DEVELOPMENT APPLICATION ASSESSMENT REPORT

Application Number:	DA2022/2251
----------------------------	-------------

Responsible Officer:	Brittany Harrison
Land to be developed (Address):	Lot 7 DP 6462, 2 The Crescent NORTH NARRABEEN NSW 2101
Proposed Development:	Alterations and additions to a dwelling house including carport
Zoning:	R2 Low Density Residential
Development Permissible:	Yes
Existing Use Rights:	No
Consent Authority:	Northern Beaches Council
Land and Environment Court Action:	No
Owner:	Brendan Christopher Worsley Jade-Tanya Worsley
Applicant:	Brendan Christopher Worsley

Figure 1: Western Building Envelope Encroachment

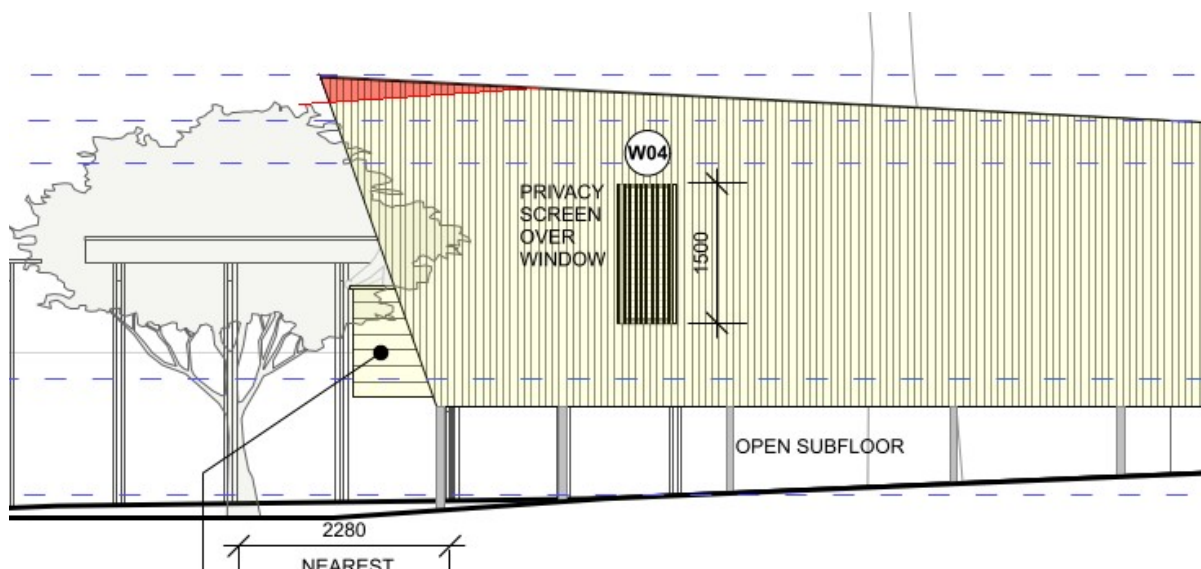
The proposed development encroaches the side building envelope on the western side, with a maximum variation of 5.7% when measured from existing ground level. See Figure 1 below.

A variation however is allowed if the site is subject to Flood Hazard Controls, the building envelope shall be measured from a height above the minimum floor level requirement under the Flood Hazard Controls. The subject site falls within the Low to High Flood Hazard Map, and is subject to a minimum floor level of 3.53m AHD.

In light of the above, when the side building envelope is measured from the minimum floor level, the development will fall within the required building envelope and is compliant with this clause.
